Amendments to the Drawings

REMARKS

FIG. 1A

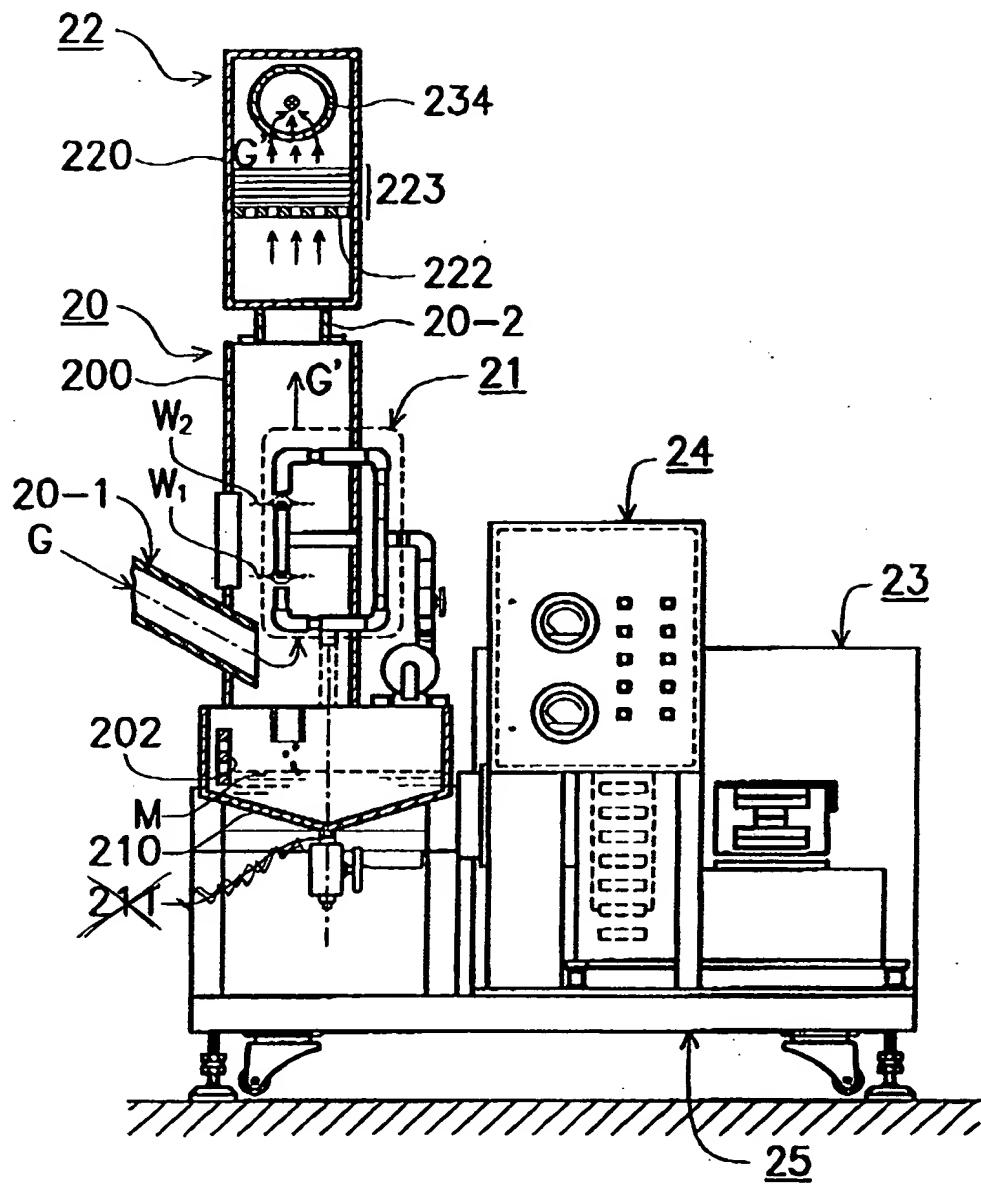
The attached sheet of drawings includes changes to Fig. 1A, wherein reference number 211 has been deleted because it is not referred to in the specification, as per the Examiner's request.

The drawings are objected to under 37 CFR 1.84(p)(5) because element "211" in Fig. 1A is not mentioned in the specification. Applicants propose deleting element 211 from Fig. 1A. Proposed drawing corrections in red ink along with corrected drawings in accordance with the proposed changes are enclosed herewith.
